BULLETIN CT-01

Date: September 1st, 2022	Number: CT-1	Project #: 21162
Project Name: Piper Remodel	Attached: REV2 structural drawings (Delta 2 – Bulletin CT-1)	
Number of Pages: 17

Subject: Grade beam revisions
Main Floor framing revisions
Main Floor sheathing addition (thickness and nailing)

Drawings affected: S2.0, S2.1

Main Floor Framing Over Basement Level Shear Walls

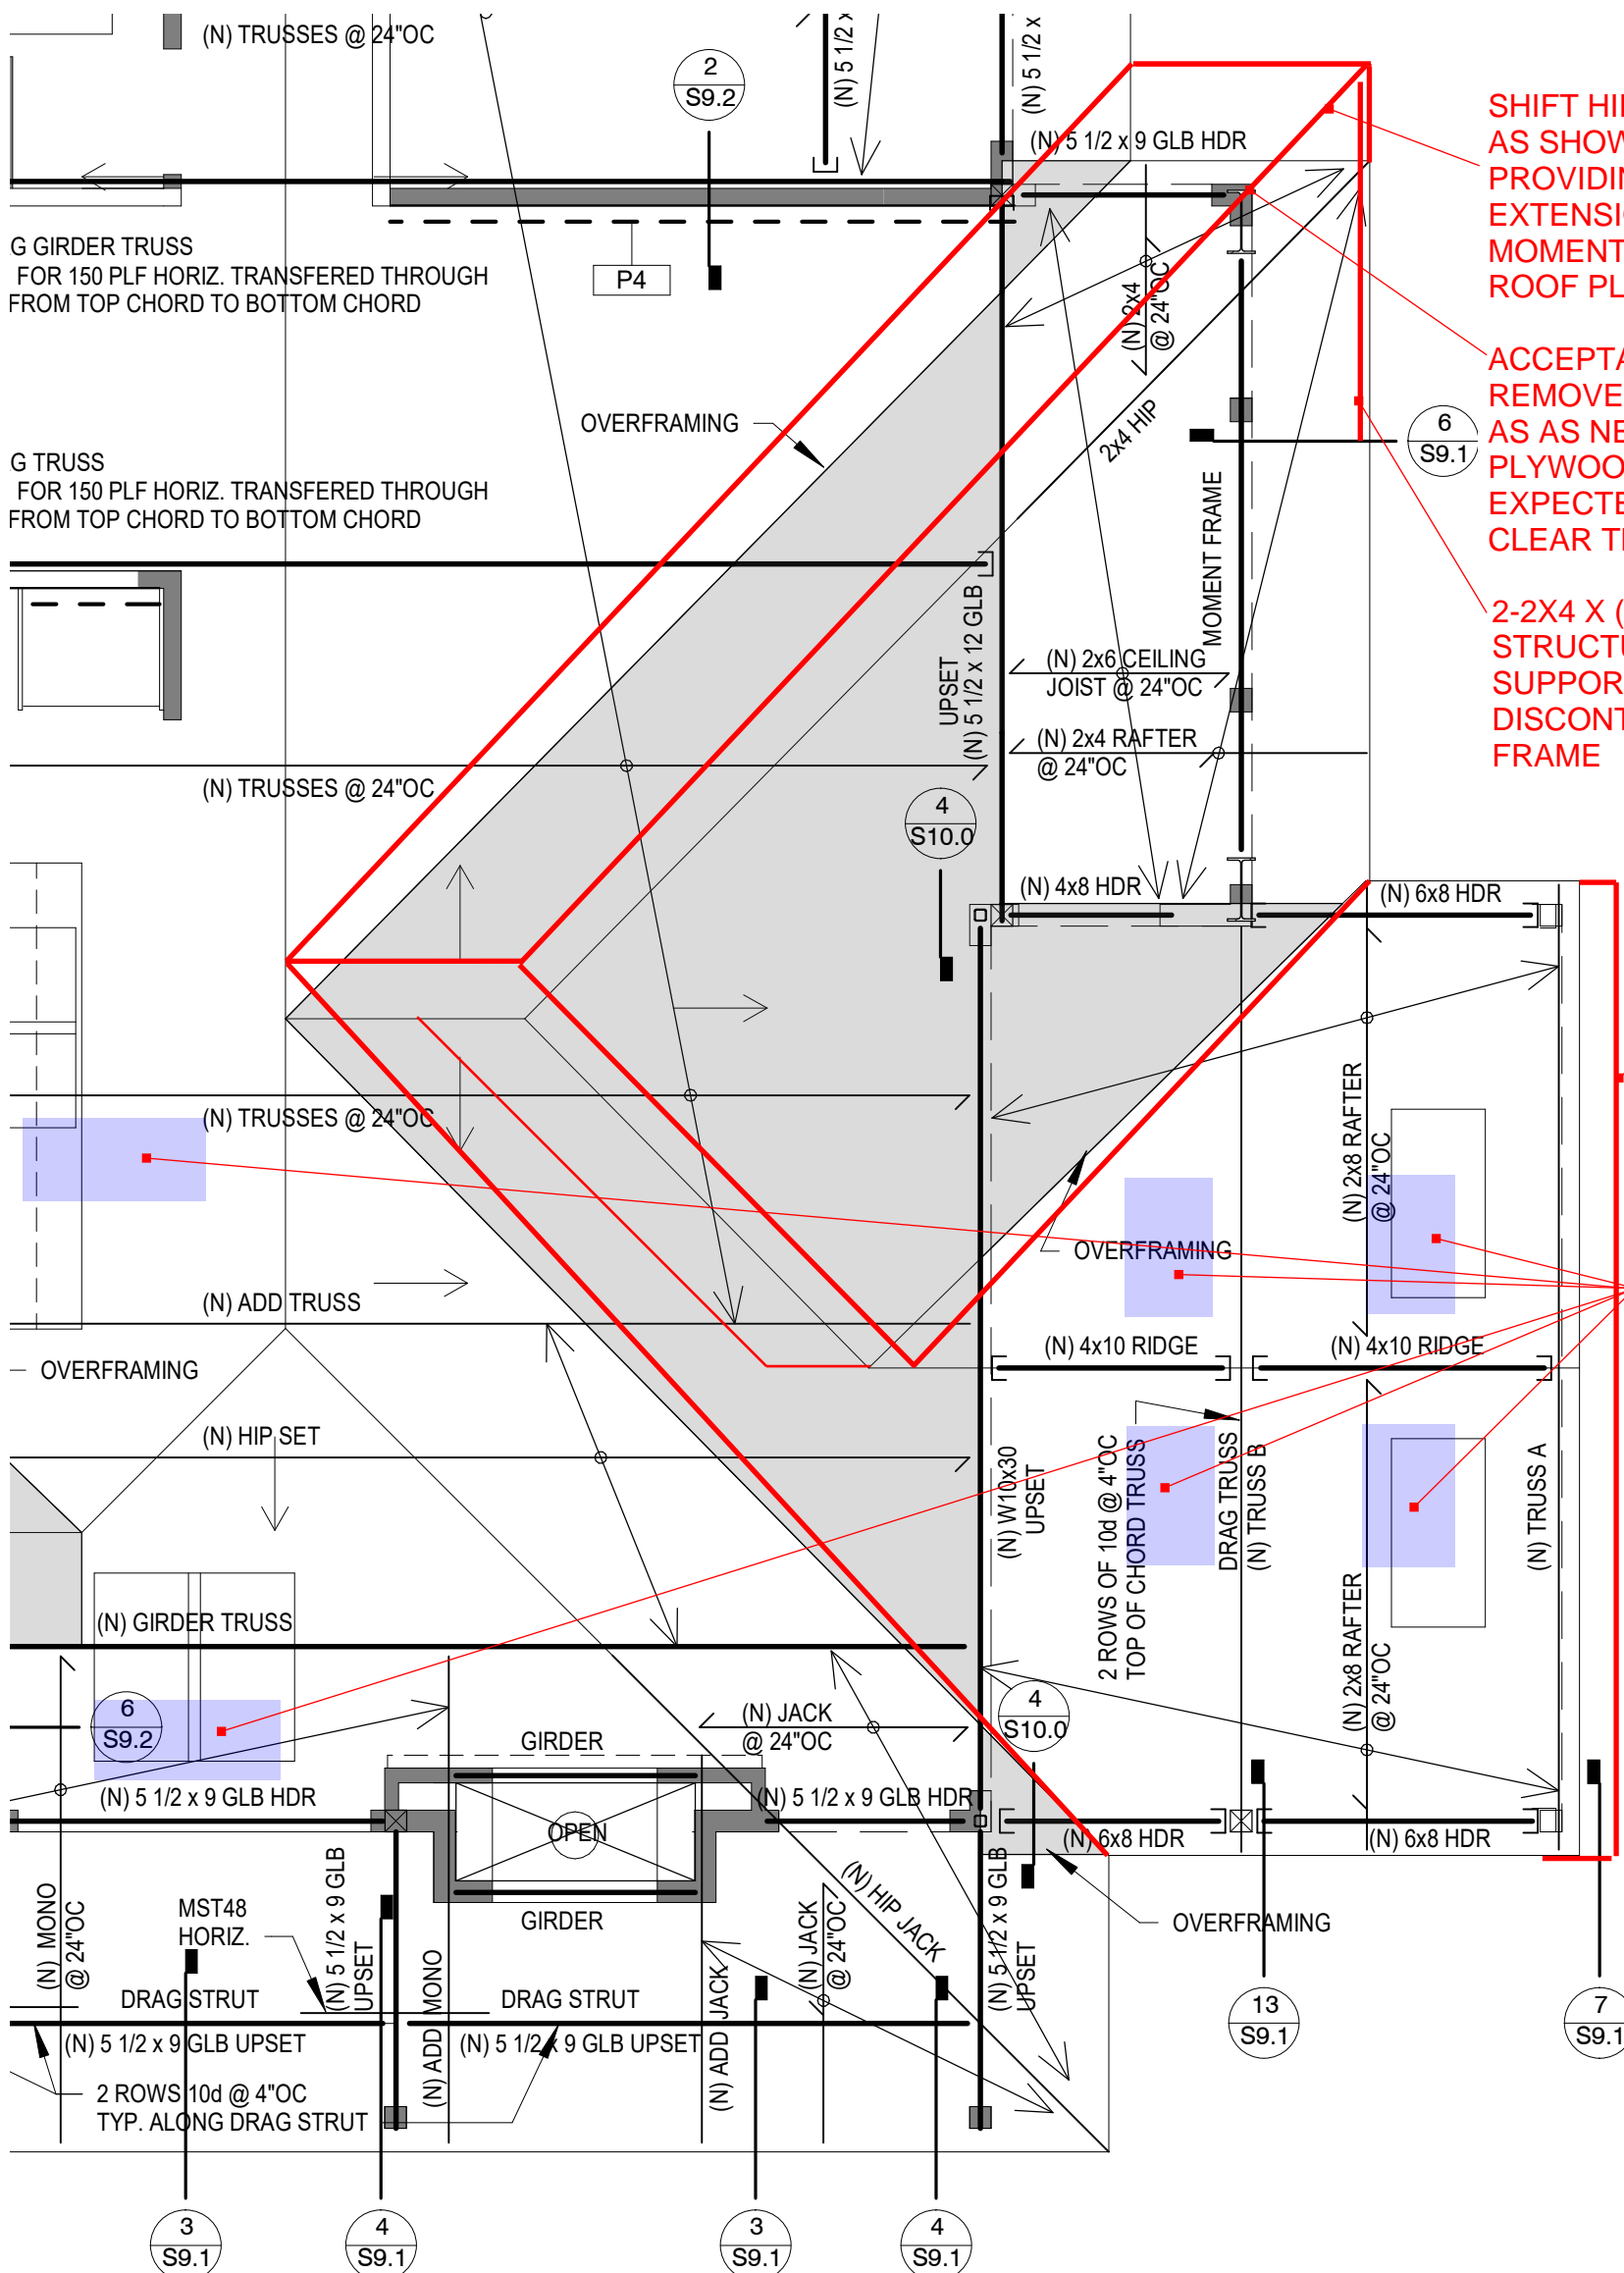
We understand that the existing exterior headers just to the south of the deck are existing 4x8. We understand that the current coordinated architectural layout locates the 8 3/4" GLB supporting the deck framing between two 5'-6" openings, therefore this GLB will not load the existing headers. It is structurally acceptable to sister a 2x8 DF#1 to the side of the existing 4x8. Provide sistering nailing per detail E of Bulletin CT-03.

Please support the 8 3/4" X 12" GLB with a HGLT9 (H=14 3/4") w/ 18-N54A at existing 4x8 header & 6 – N54A at the glued-laminated beam. Contractor to verify hanger height (T.O. existing 4x8 assumed to be 2 3/4" higher than the dropped 8 3/4" X 12" GLB supporting the deck.

Roof Framing Over Main Level Shear Walls

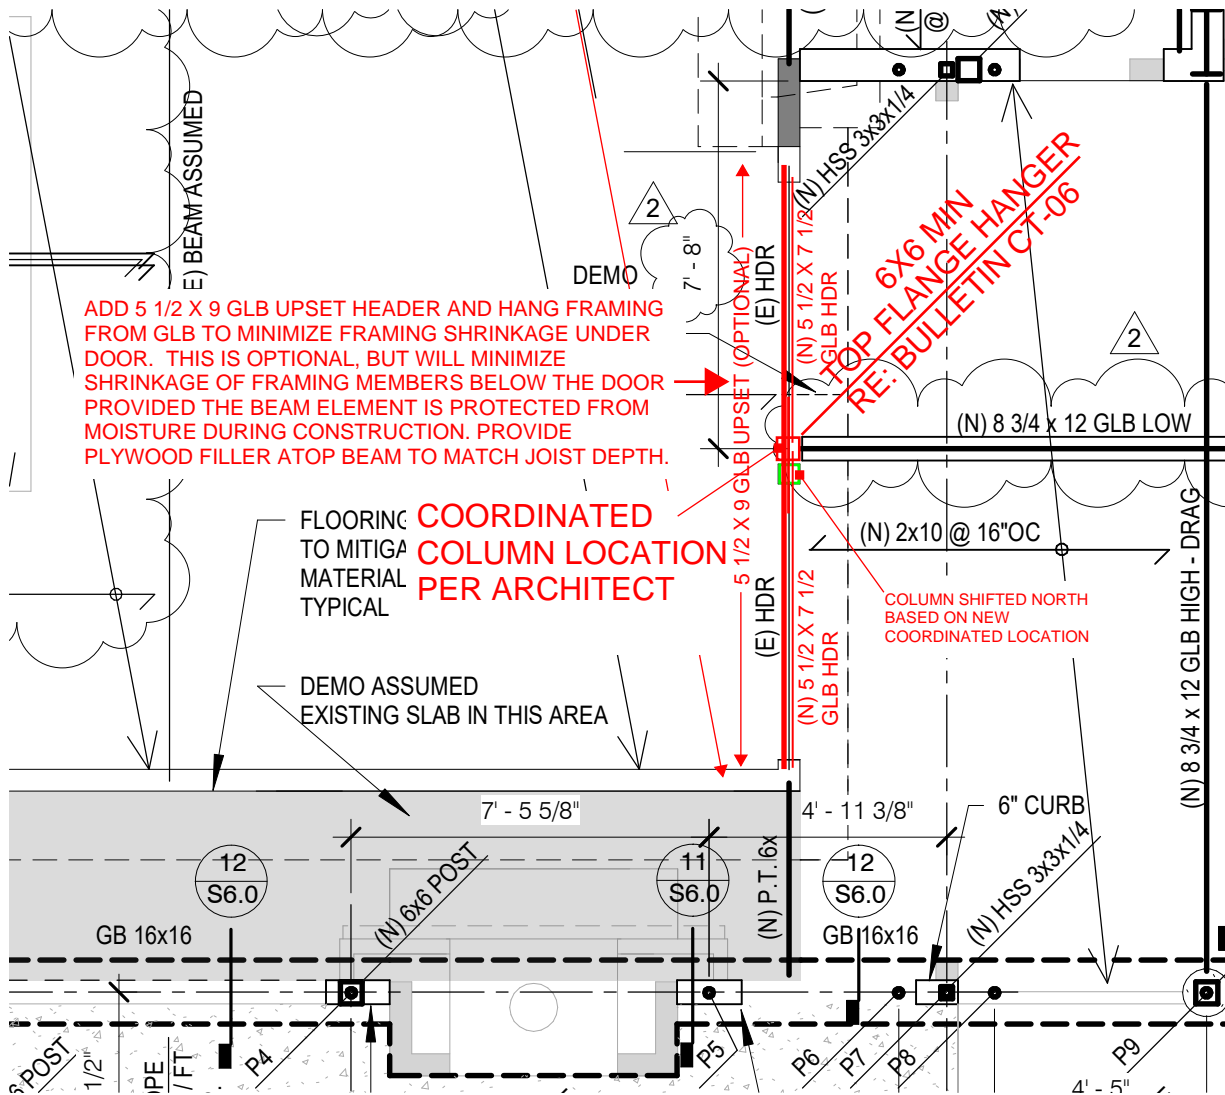
SHIFT HIPS AND VALLEYS AS SHOWN IN RED - REFER TO ARCHITECTURAL REVISED ROOF PLAN FOR VALLEY AND HIP ANGLES, PROVIDING NORTH END EVE EXTENSION TO HOUSE MOMENT FRAME BELOW ROOF PLYWOOD LEVEL.

ACCEPTABLE TO LOCALLY REMOVE WOOD TOP PLATE (ATOP STEEL FRAME) AS NEEDED TO CLEAR PLYWOOD. FRAME EXPECTED TO ENTIRELY CLEAR THOUGH.

Additionally, please see revised roof plan with extended eave at the north end of the stairs as well as slight hip and valley angle revisions to accommodate housing the north side moment frame leg below the roof line. We have revised these lines based on current architectural backgrounds. Refer to the architectural drawings regarding roof slopes and valley and hip angles in this area.

Main Floor Framing Over Basement Level Shear Walls

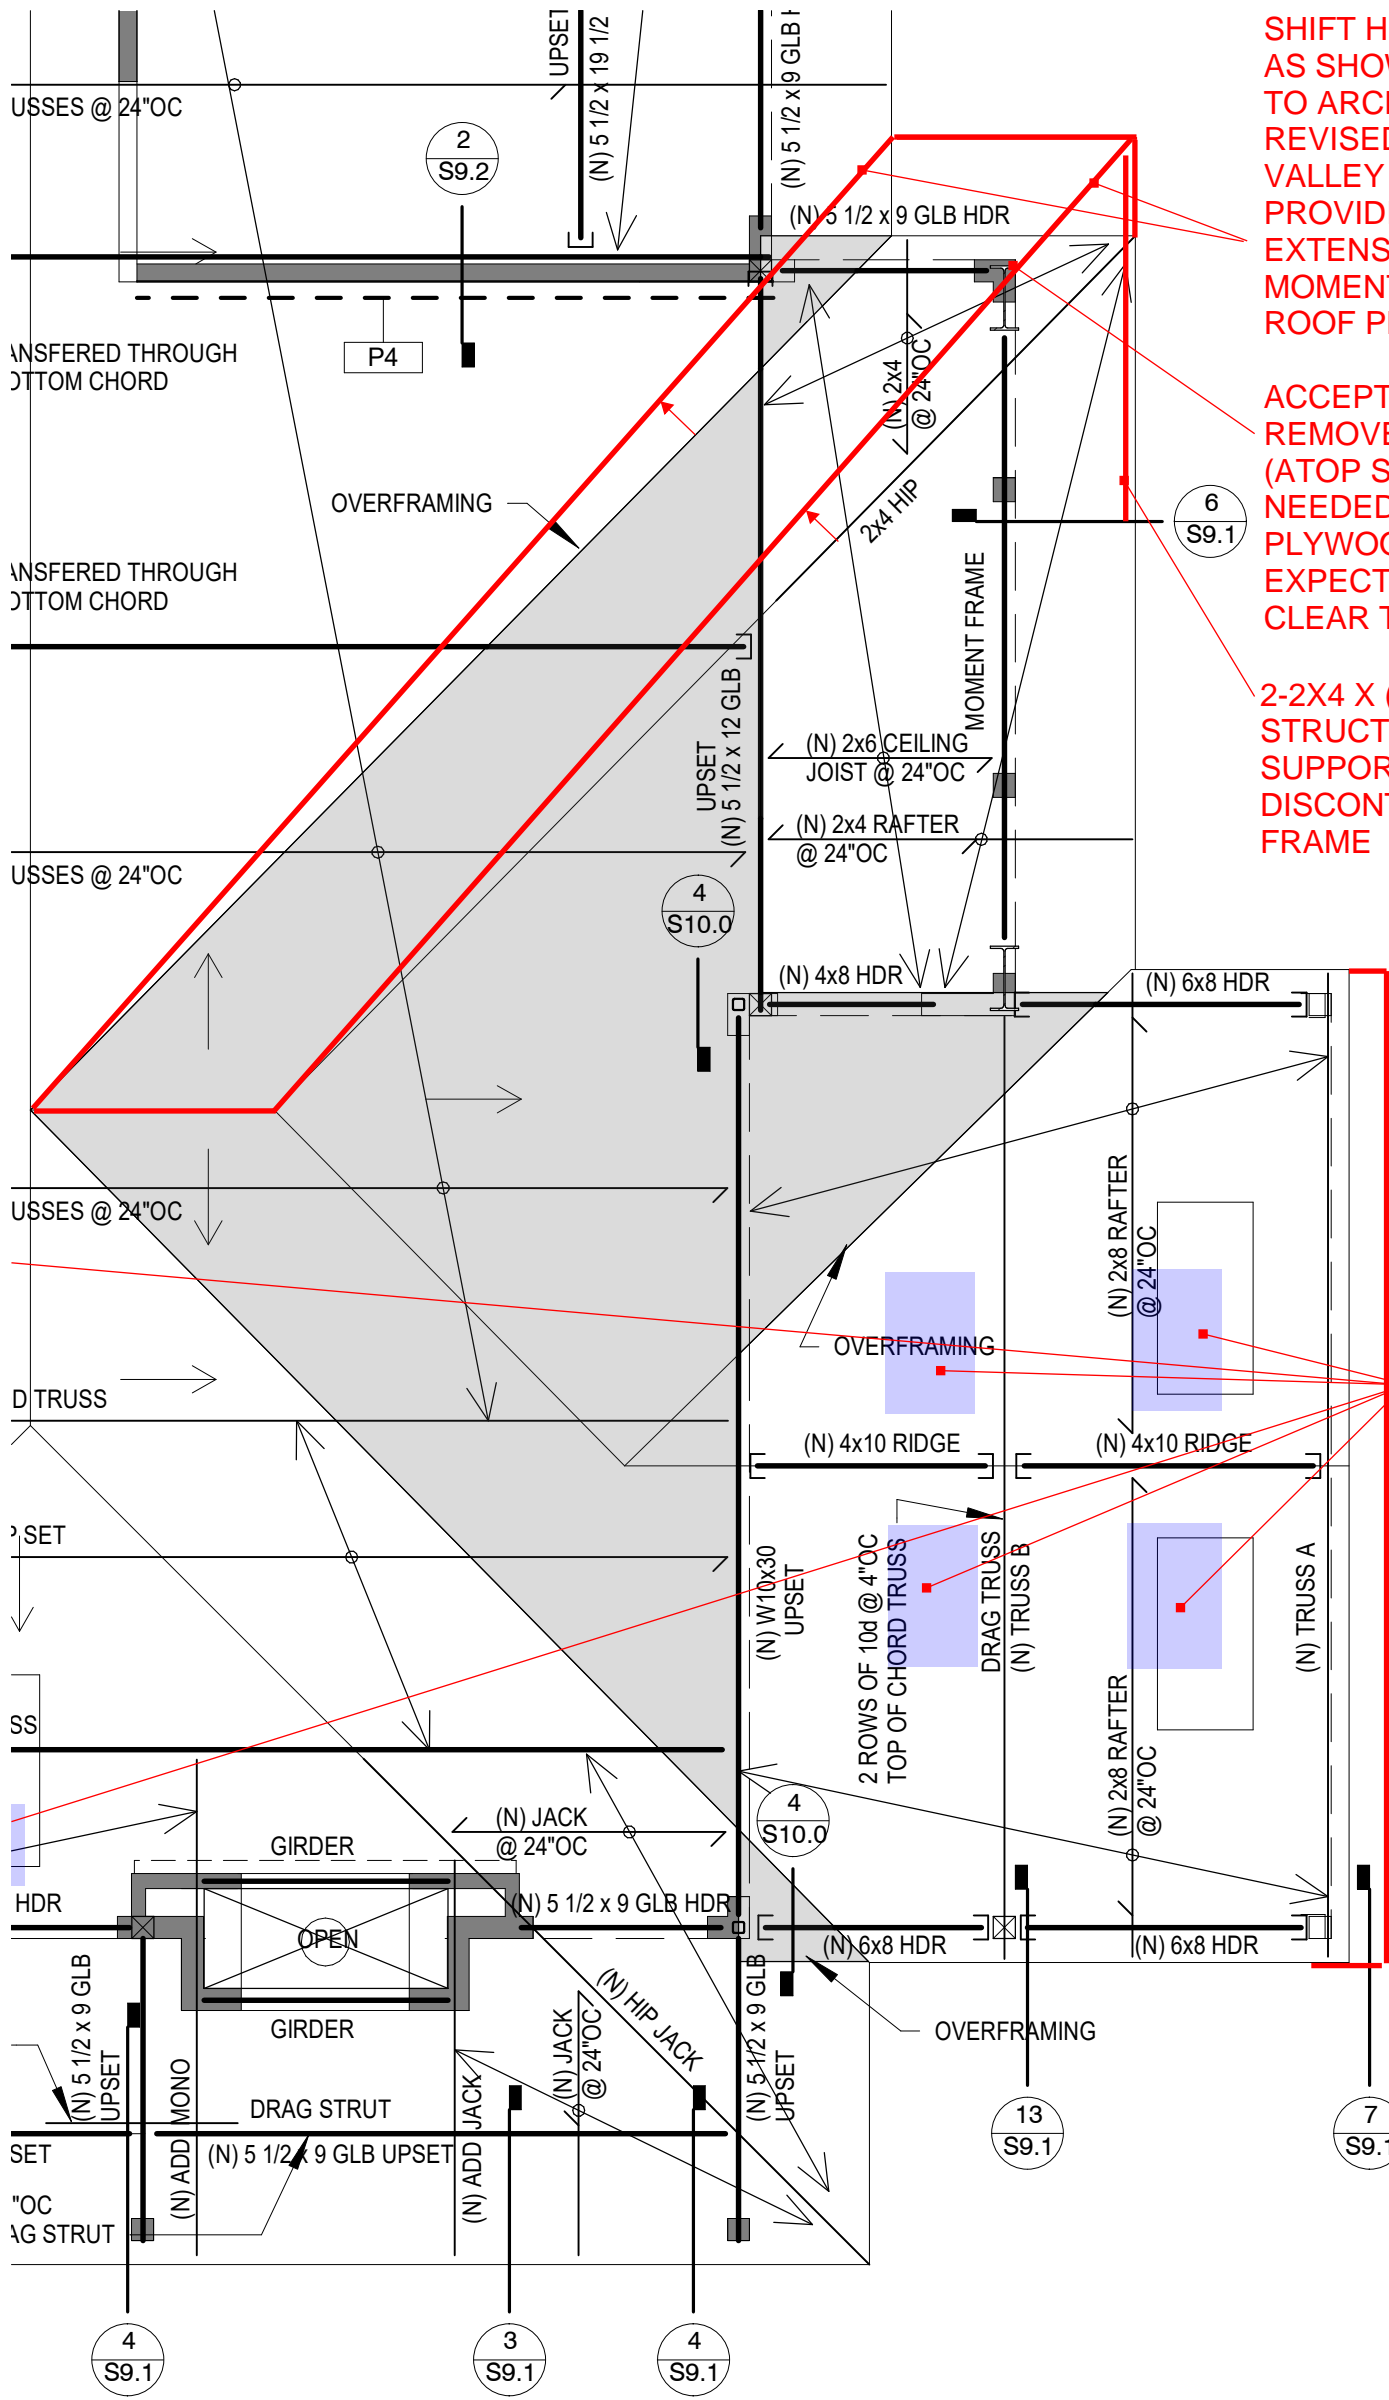
We understand that the existing exterior headers just to the south of the deck are existing 4x8. We understand that the current coordinated architectural layout locates the 8 3/4” GLB supporting the deck framing between two 5’-6” openings, therefore this GLB will not load the existing headers. **Please replace both existing headers with 5 1/2 x 7 1/2” 24F-V4 glued-laminated beams. Provide solid blocking between the joist under the new door in this area (or add additional upset header as discussed below). We understand that the contractor is concerned regarding the long-term operation of the door assembly caused by framing deflections. Please note that the current live load deflection of the headers is 0.043” and the total load deflection equates to 0.078”. Additionally, some shrinkage will occur in the dimensional lumber framing below the door, and this will depend on the moisture content of the framing when the door is installed. To minimize shrinkage below the door assembly, a header can be added atop the double top plate and joist hung into the upset header (5 1/2 X 9 glued-laminated beam). This member should be protected from moisture during construction to minimize shrinkage of the beam element after the door is installed. This header in the joist space can be added in addition to the lower headers to reduce the overall deflection / shrinkage of the framing system below the door assembly, however additional movement in the framing is possible due to natural soil settlements.**

Please support the 8 3/4” X 12” GLB with a HGLT9 (H=14 3/4”) w/ 18-N54A at existing 4x8 header & 6 – N54A at the glued-laminated beam. Contractor to verify hanger height (T.O. existing 4x8 assumed to be 2 3/4” higher than the dropped 8 3/4” X 12” GLB supporting the deck. **We now understand that the deck will be a flow-through deck. Provide hot-dipped galvanized hangers and stainless-steel fasteners typically.**

REVISED 01/11/2023

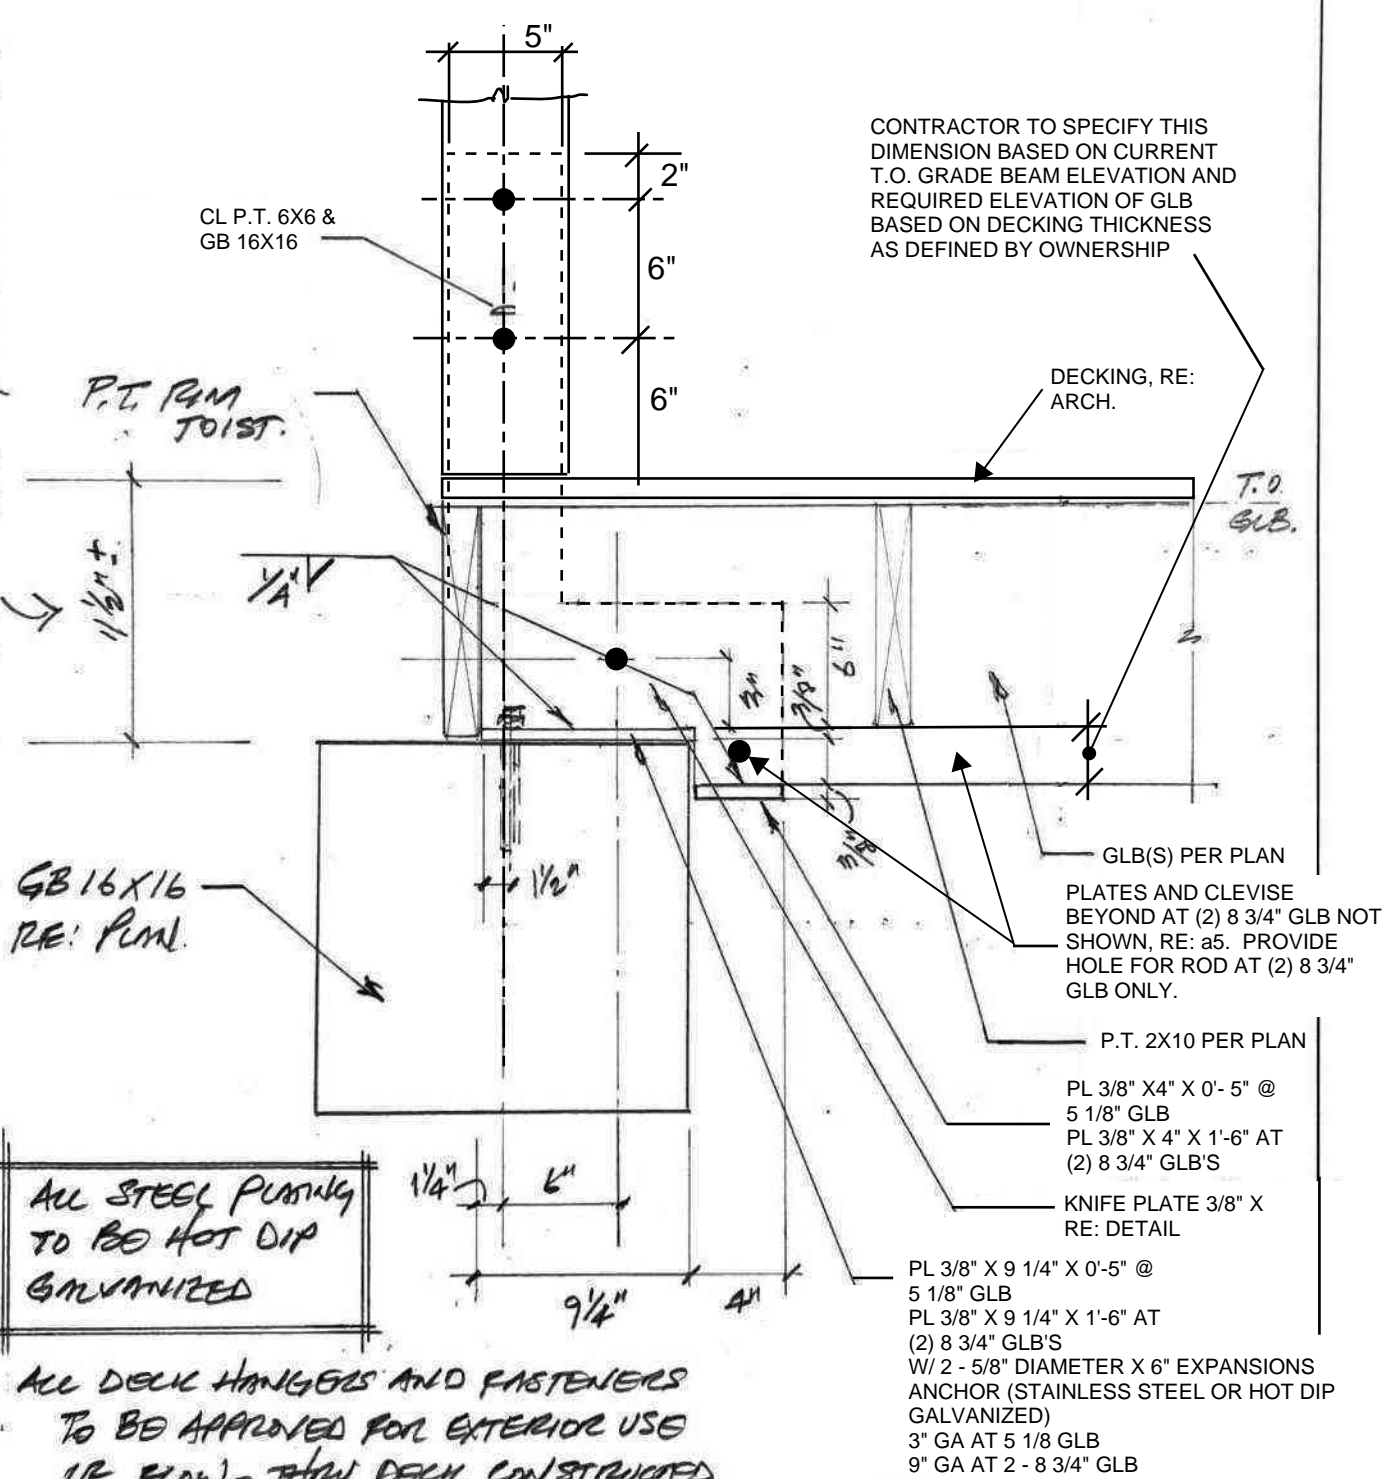
D of BULLETIN
CT.03 HAS BEEN
REVISED FOR
LARGER CENTRAL
BEAM (2- 8 3/4 X 12)
(SEE ATTACHED)
